<Question>

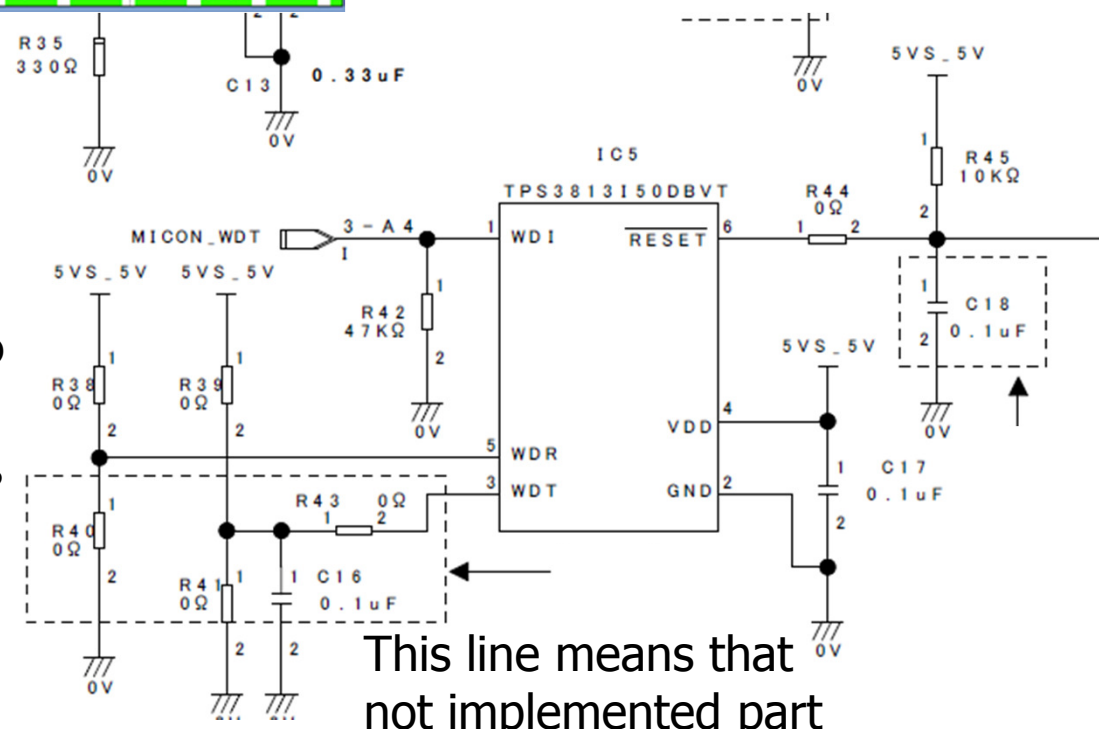
Above figure, even though WDI is low, but Reset is toggled ON –OFF with 22ms cycles.

So, usually, WDT has to be connected to GND or VDD or Capacitance. This case is OPEN.

Is there the problem relation to above figure?

This line means that not implemented part
